NEBRASKA CAPITOL ENVIRONS COMMISSION STAFF REPORT

APPLICATION NUMBER Urban Design Record #24008
APPLICATION TYPE Certificate of Appropriateness
ADDRESS/LOCATION 220 Centennial Mall S
HEARING DATE January 26, 2024
ADDITIONAL MEETINGS February 25, 2022 and July 28, 2023
APPLICANT Drew Sova, 402-408-0005, dsova@whitelotusgroup.com
STAFF CONTACT Collin Christopher, 402-441-6370, cchristopher@lincoln.ne.gov

Mural Mixed-Use Project Streetscape + Site Screening Design Review

Nebraska Capitol Environs Commission - Project Review
01.26.2022

Streetscape Design

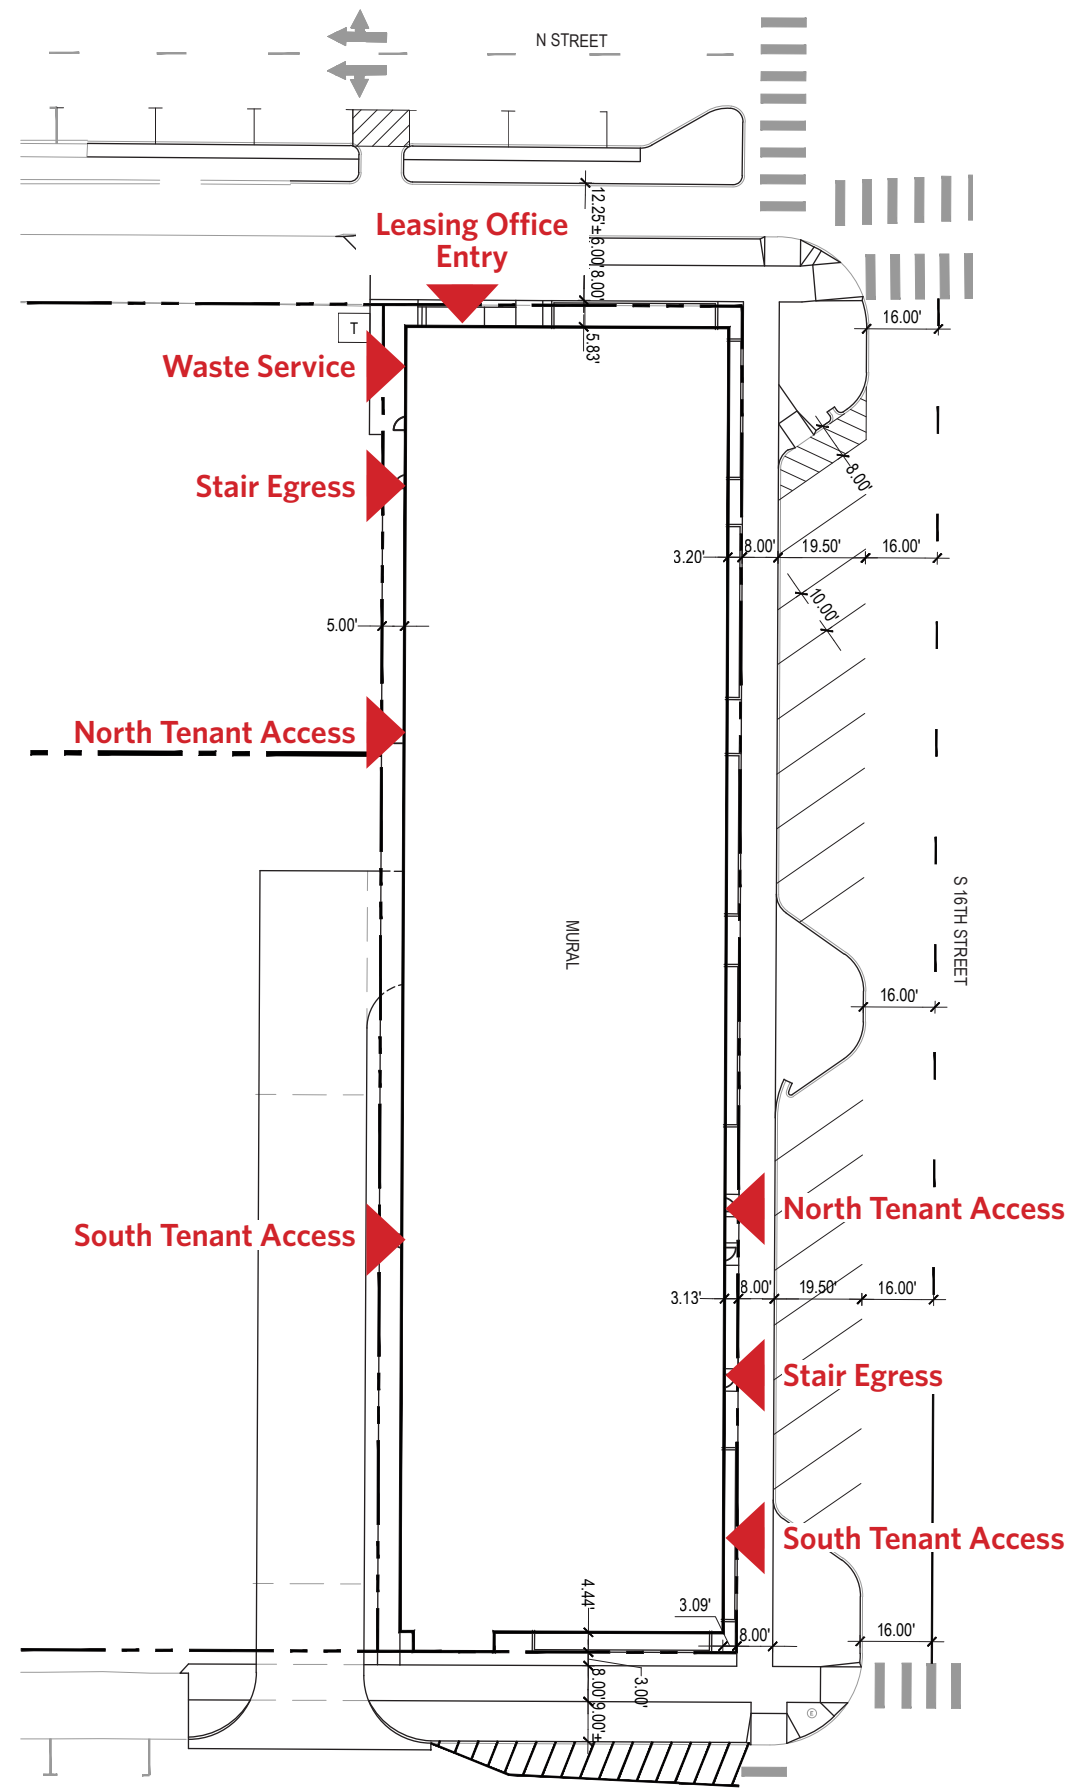
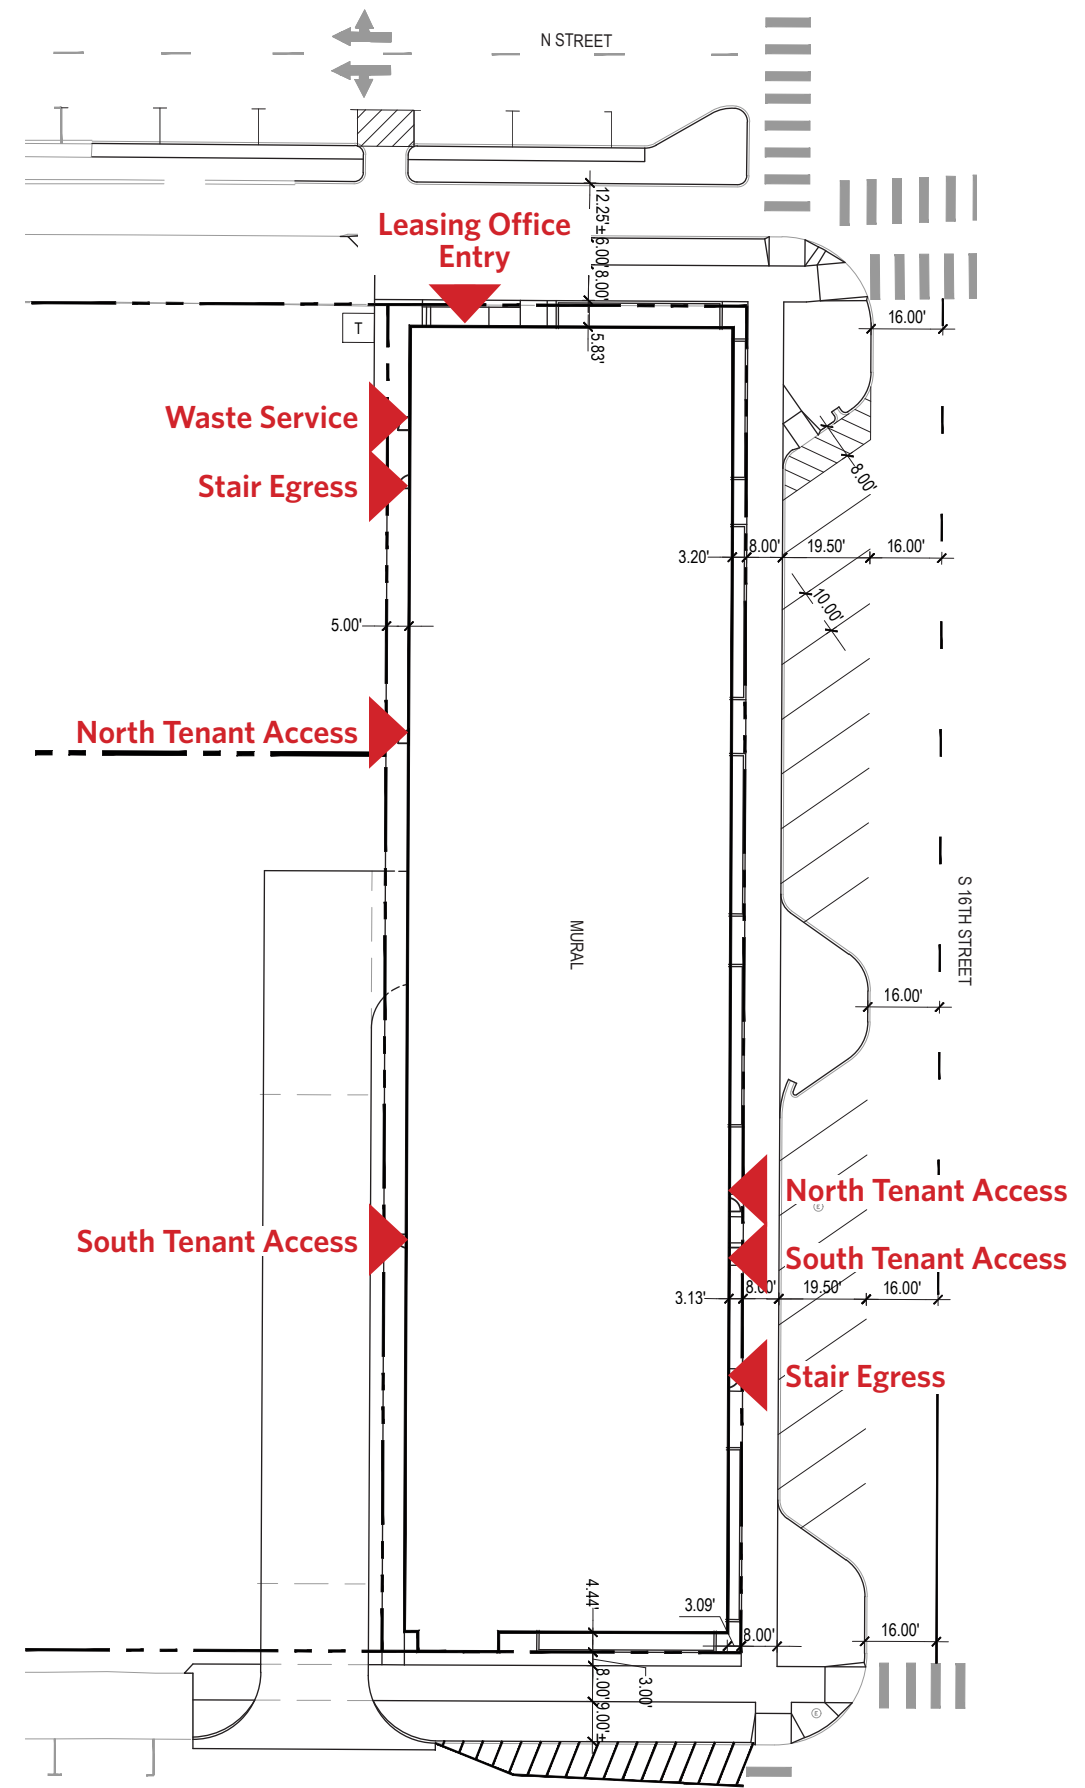
Back in February of 2022, the Commission reviewed and approved plans for the first phase of the redevelopment of the Pershing block. Then in July of 2023, they came back with some minor modifications to the site plan and building materials for the project. Those modifications were also approved. They have now developed streetscape plans for the first phase of the project and are looking for a Certificate of Appropriateness for that work. The streetscape work is mostly focused on S 16th Street, but also includes smaller portions of M and N Streets. In general, the proposed streetscape is pretty straightforward and within the context of the surrounding streetscape environment. The sidewalks are predominantly concrete, with some clay paver banding around the perimeter of the building. The 8' wide sidewalks will feel even narrower on the S 16th Streets side, where vehicle overhangs could squeeze the useable sidewalk down to 6' in spots. However, the narrow sidewalk is the best that can be achieved in order to accommodate the angled parking that the developer believes to be necessary to the success of the project.

Along the N Street side, the landscaped median protecting the cycle track has been extended nearer to the intersection. The landscaping shown throughout is appropriate to the area, and the plans indicate that at least two of the beds bumping out into S 16th Street are intended to be bioretention beds that will capture stormwater.

Compatibility per Staff Analysis: The proposed streetscape – in terms of form and material – meets the intent of the design standards. Further, the design blends well with the aesthetic of Centennial Mall and sets the stage for future improvements on the block.

Rooftop and Site Screening

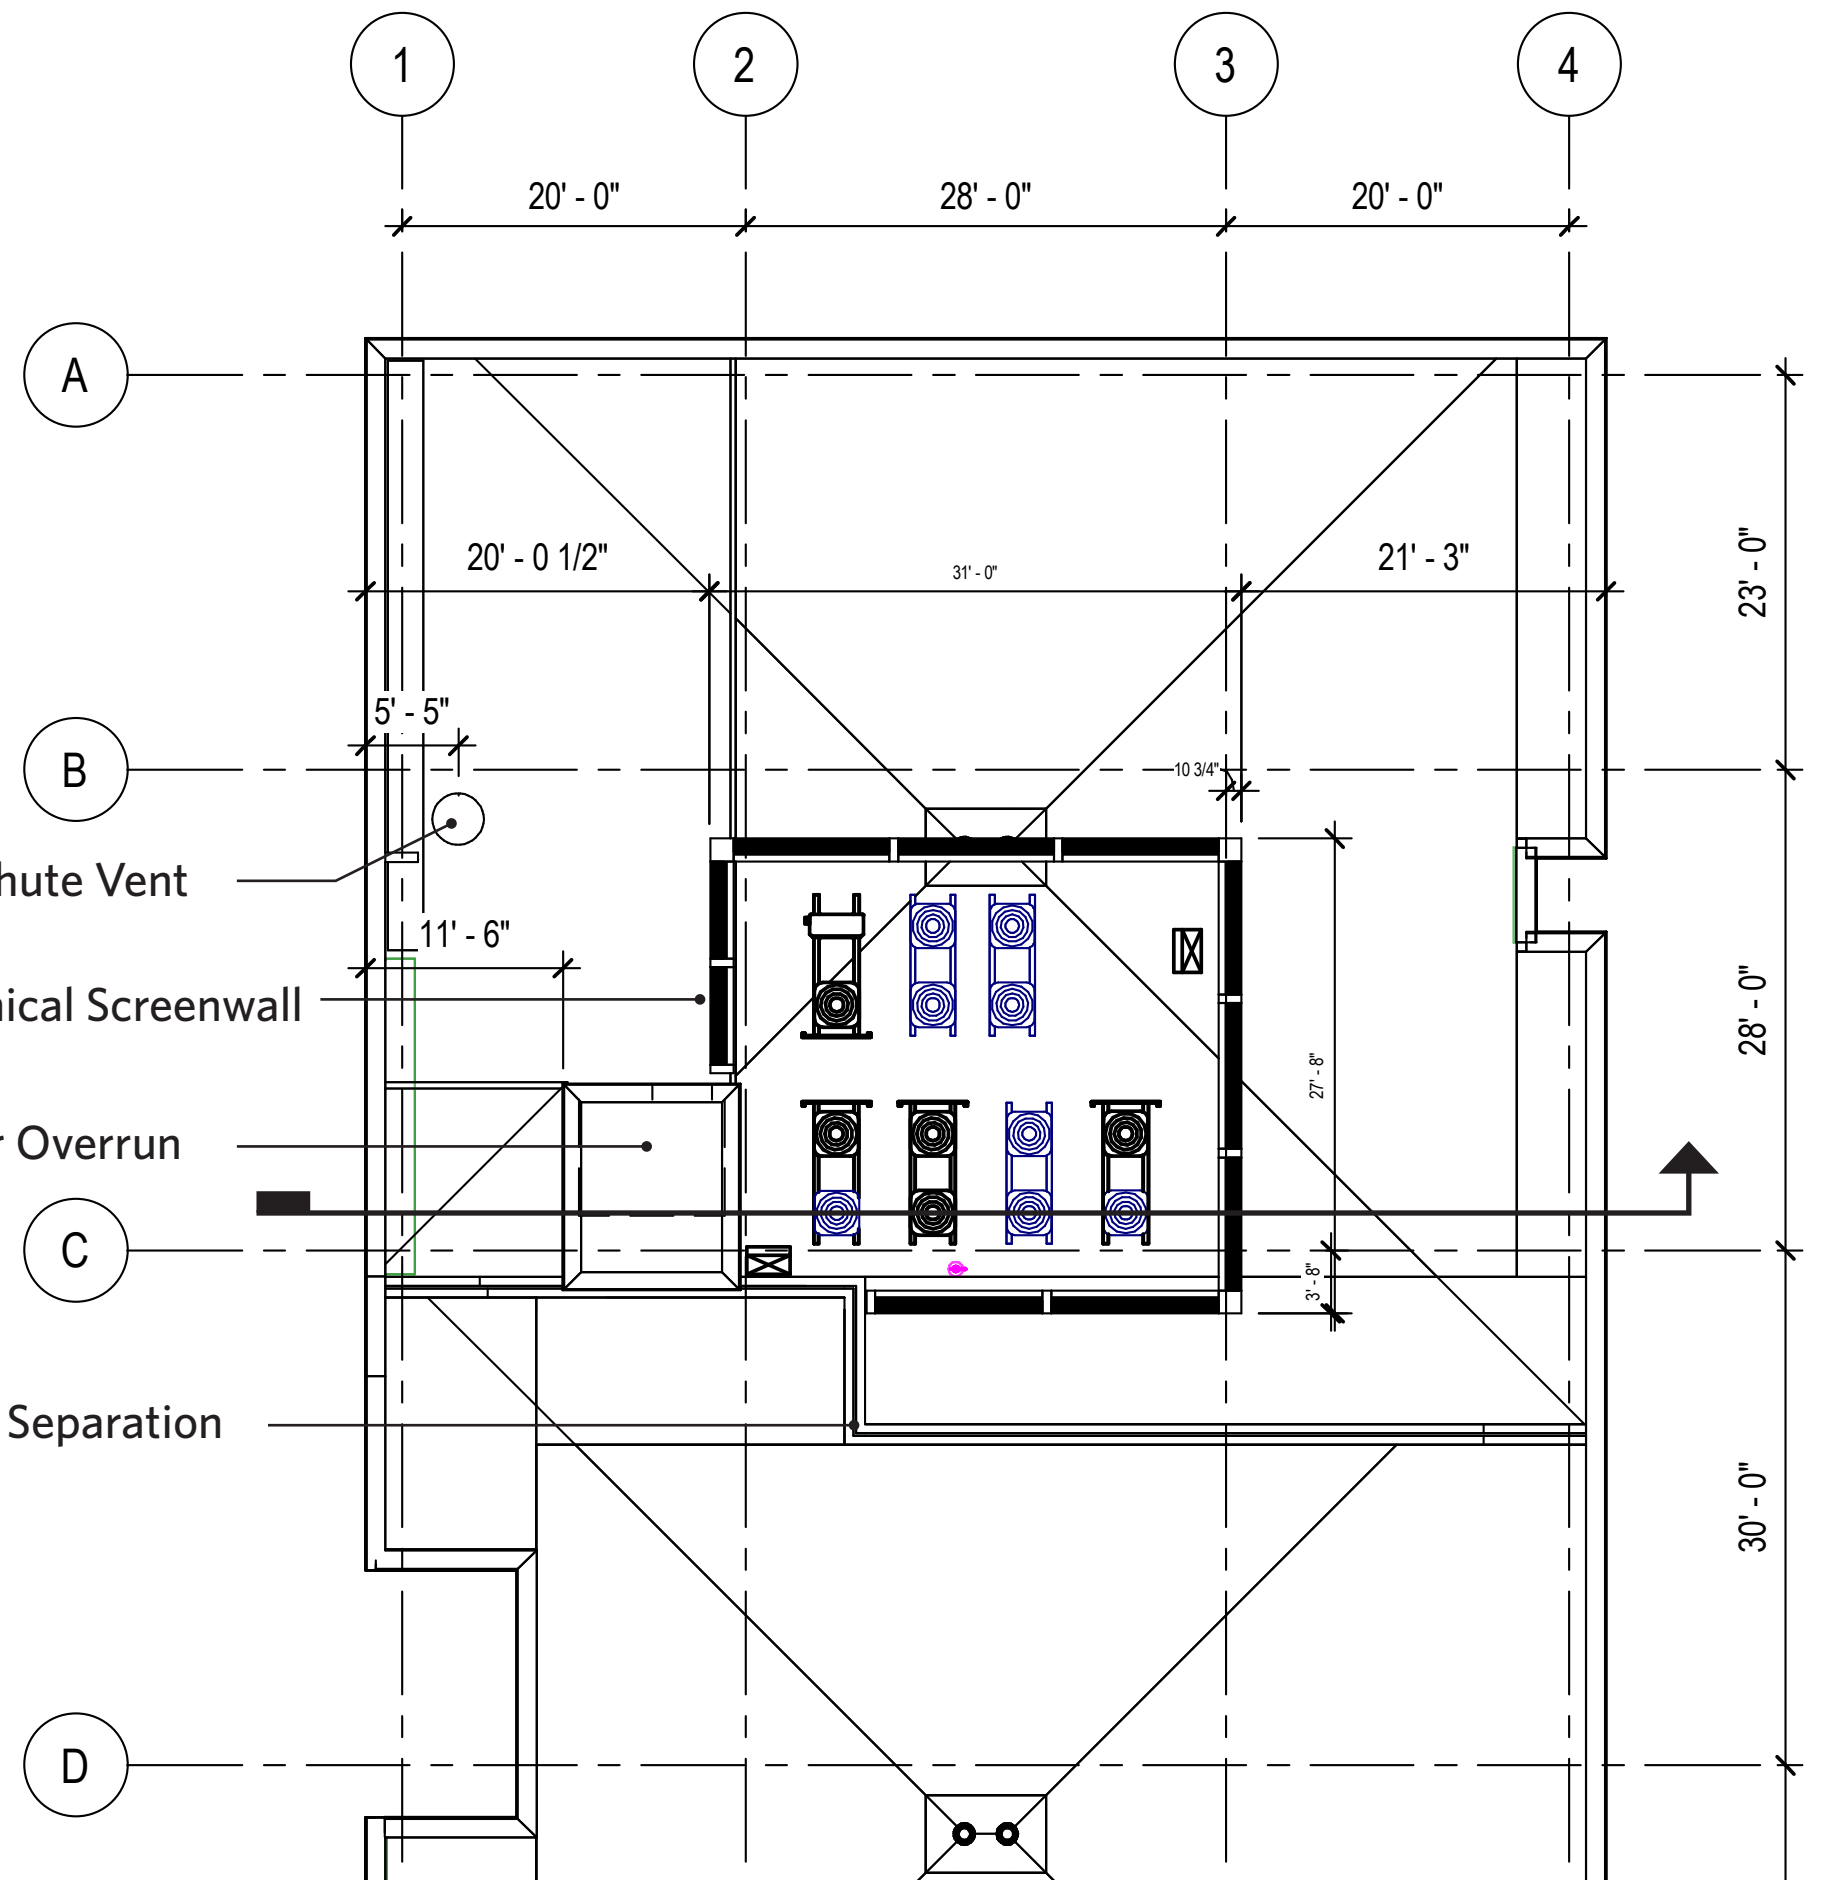
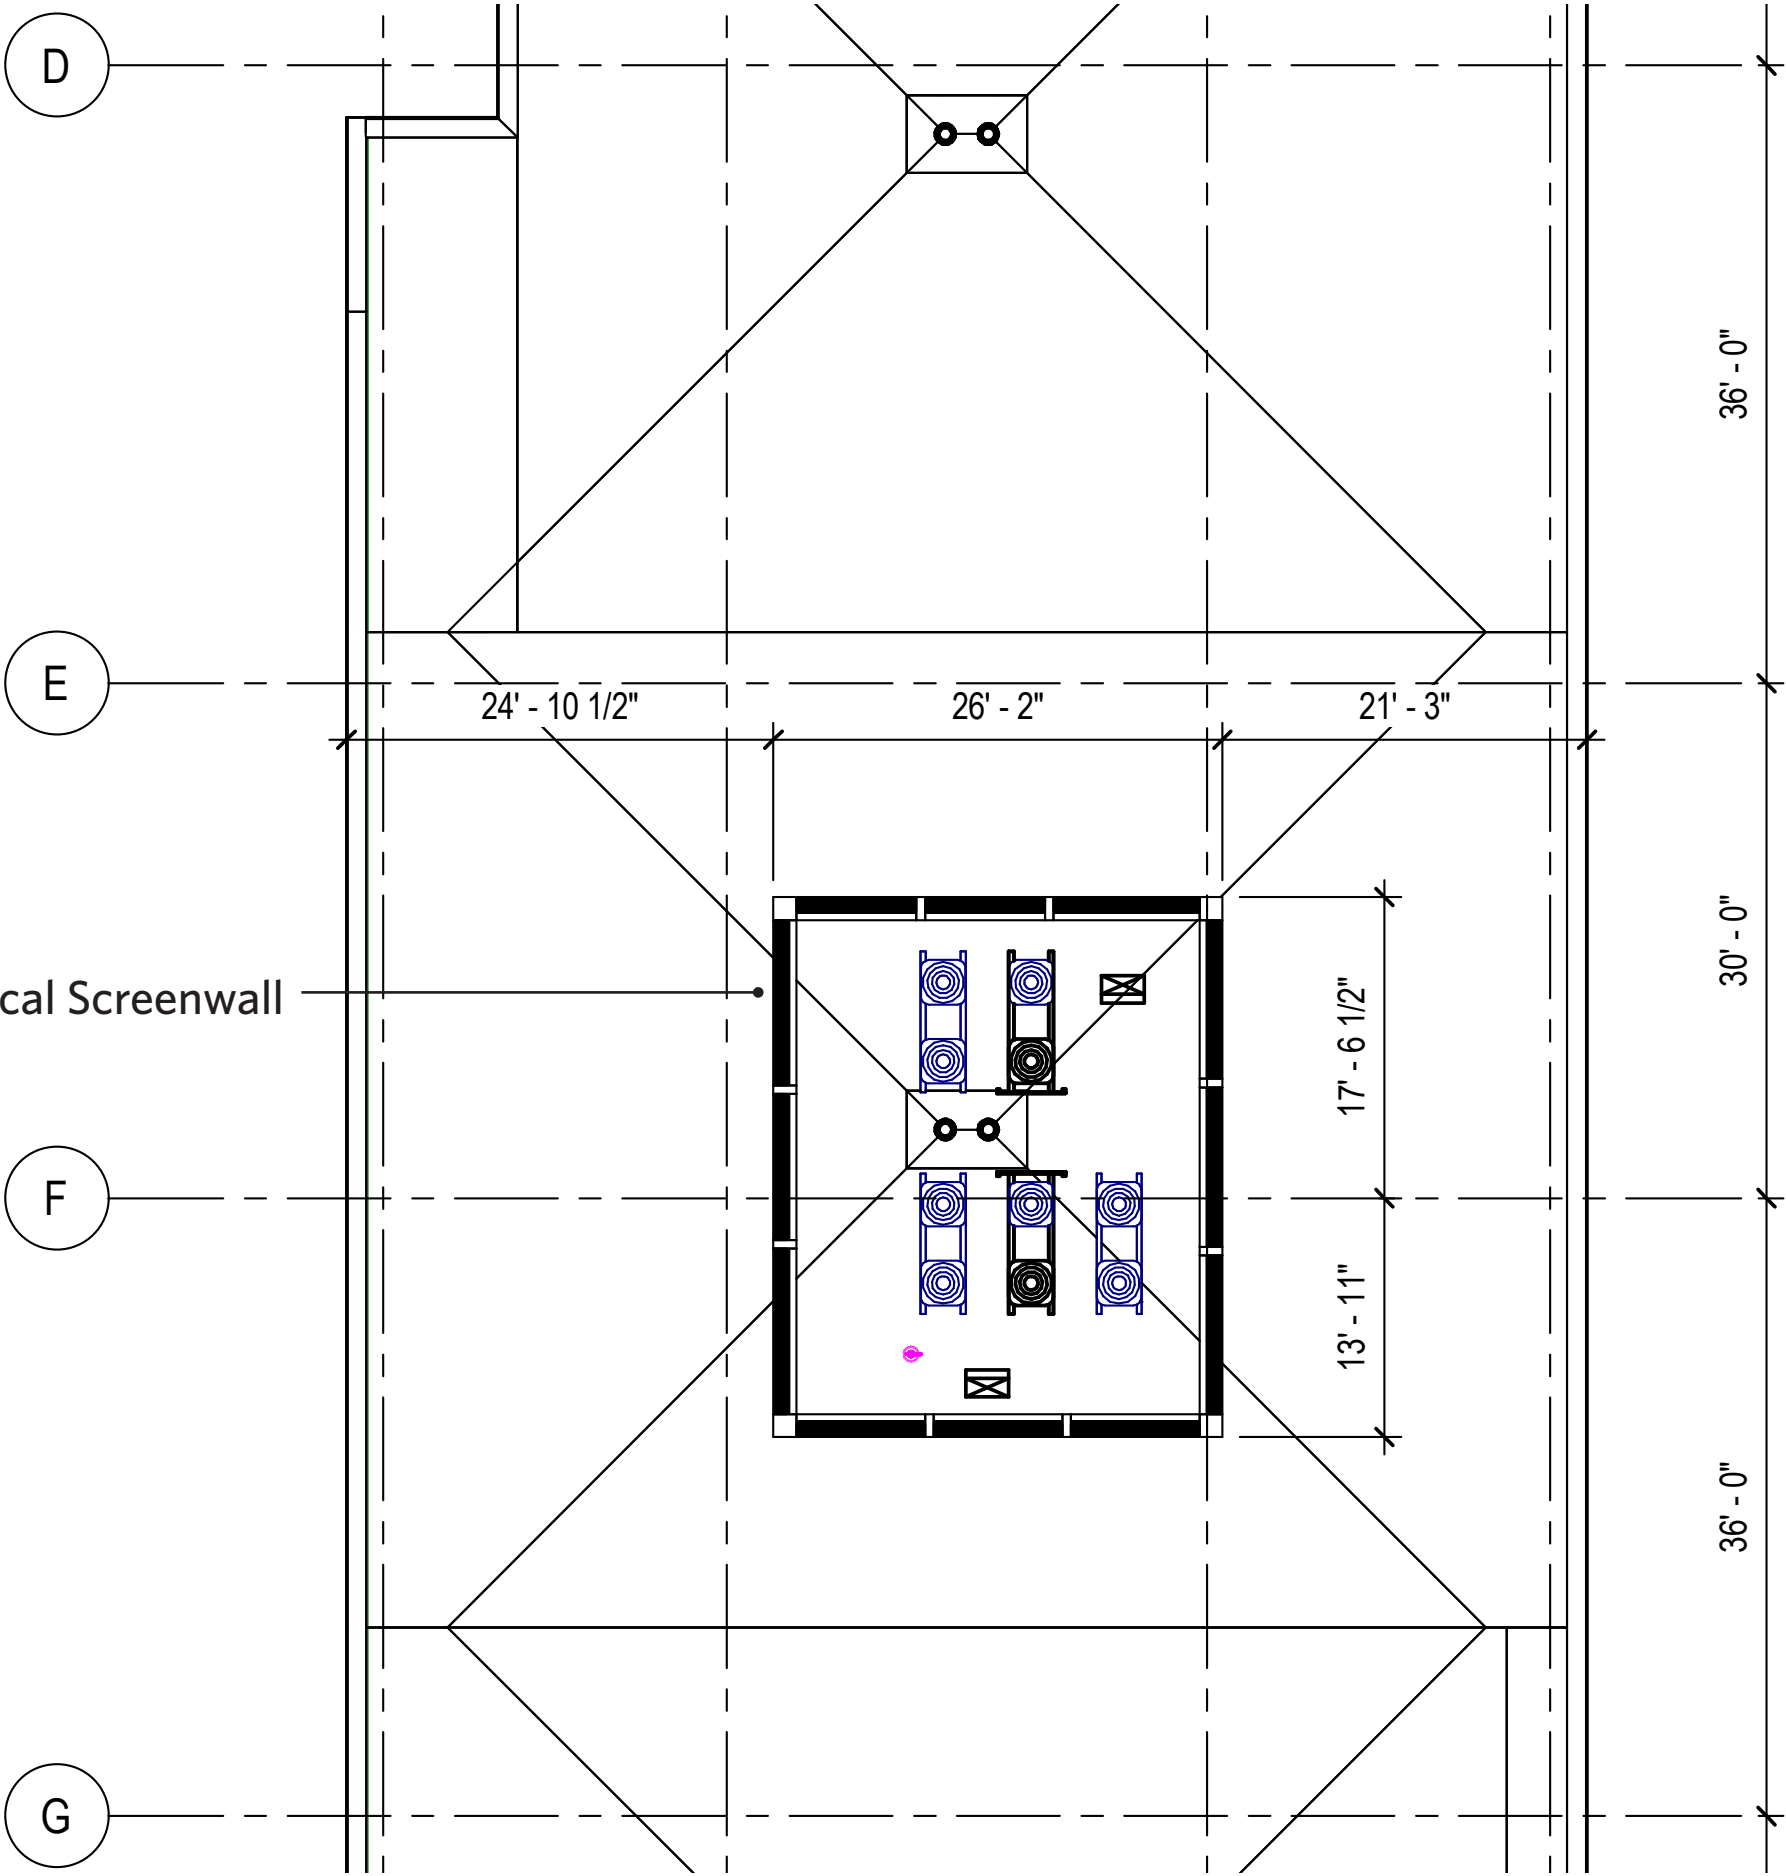
Per the request of the Commission, the applicant has also submitted additional information related to the screening of the rooftop and utility equipment and are asking for a review and approval of that as well.
